# BUILDING PERMIT REPORT

DATE: 3 June 98 ADDRESS: 413 Luke ST. (339-P-710)  
 REASON FOR PERMIT: To do interior & exterior renovations -  
 BUILDING OWNER: Christopher LaSalle  
 CONTRACTOR: L.J. Gagne  
 PERMIT APPLICANT: ↑  
 USE GROUP R-3 BOCA 1996 CONSTRUCTION TYPE 5B

LAND USE - ZONING REPORT

BUILDING CROSS SECTION (FACING SOUTHWEST ELEVATION SAT. A-100)

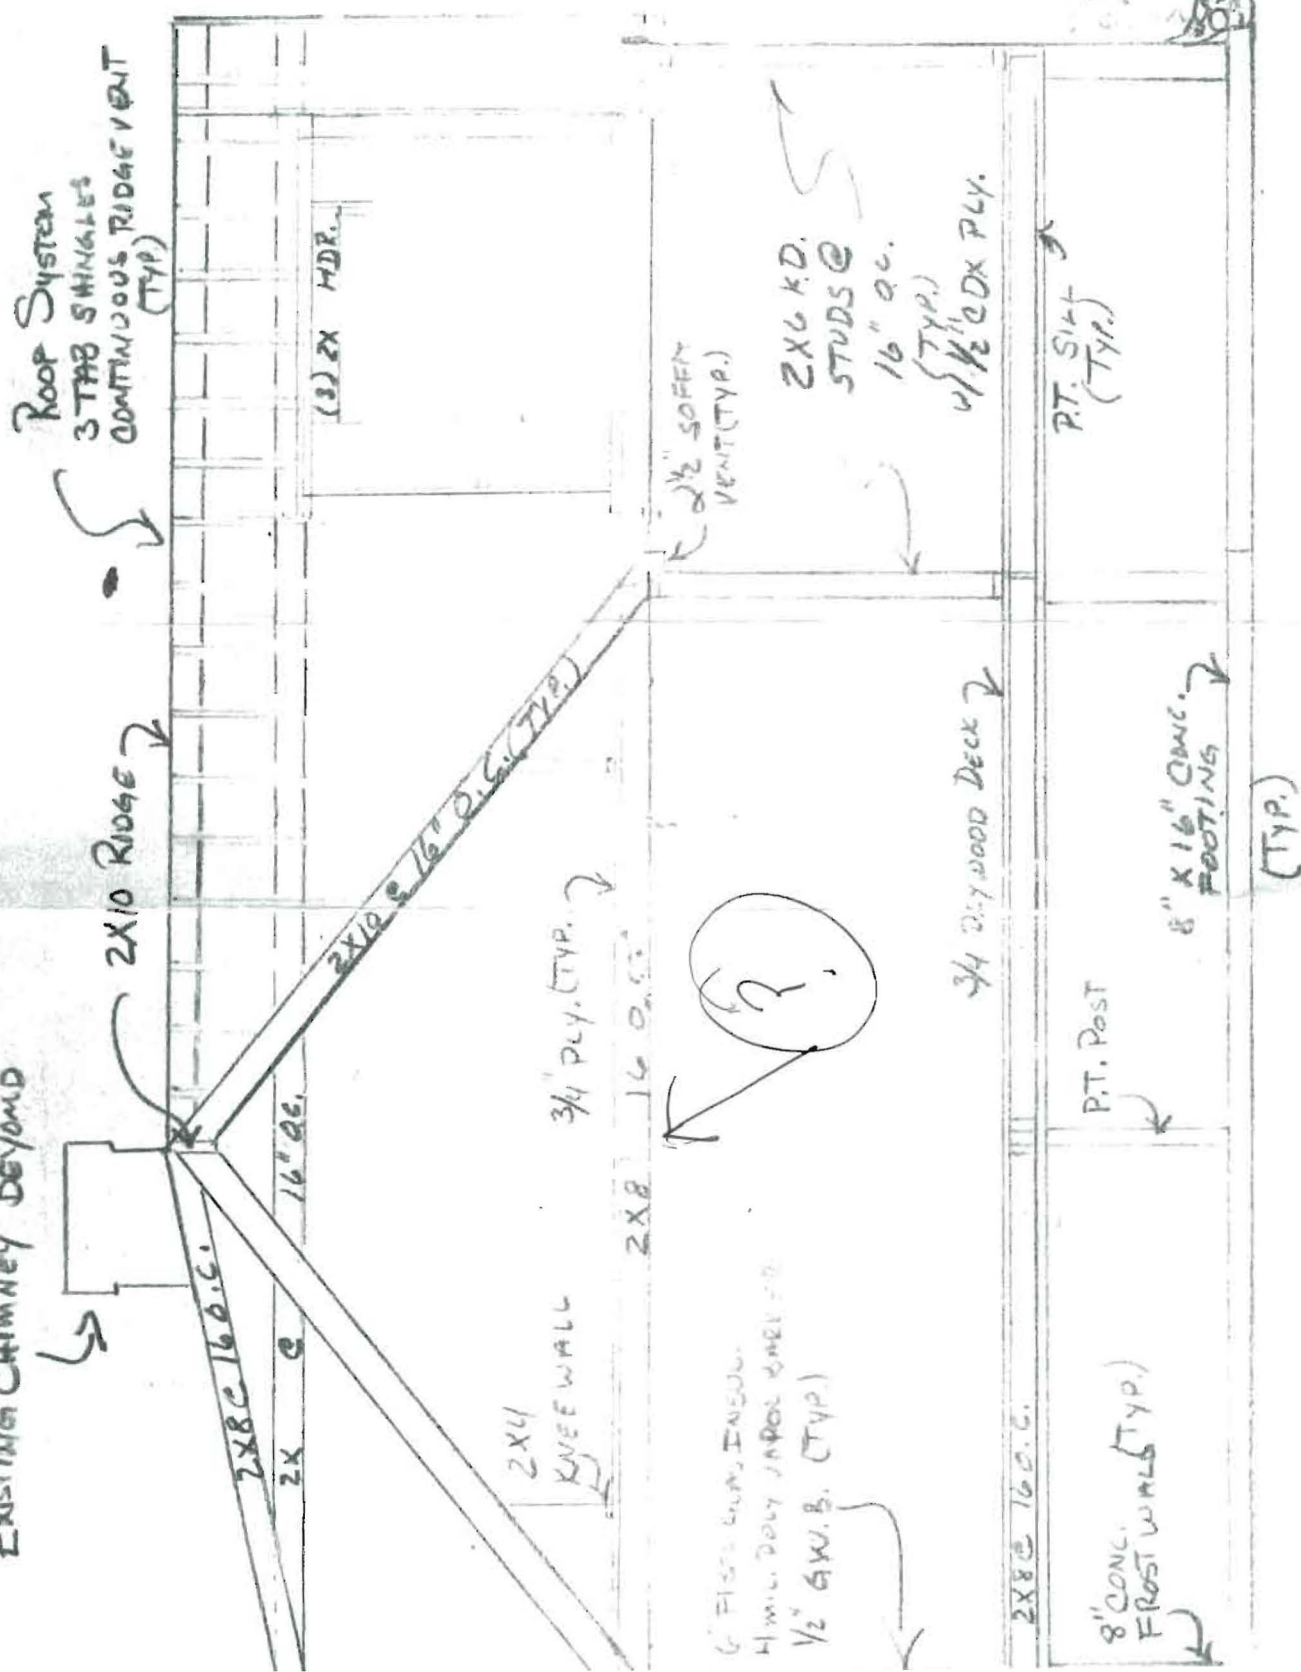
- X 29. Your proposed plan does not show a bearing wall for the second floor - Please call me with this info. - J
30. \_\_\_\_\_
31. \_\_\_\_\_
32. \_\_\_\_\_

6/12/98 - talked w/ Contractor - Will amend drawing when they open  
Center will determine bearing load - Will start 6/19 or B-4 Contractor  
will call w/ firm date
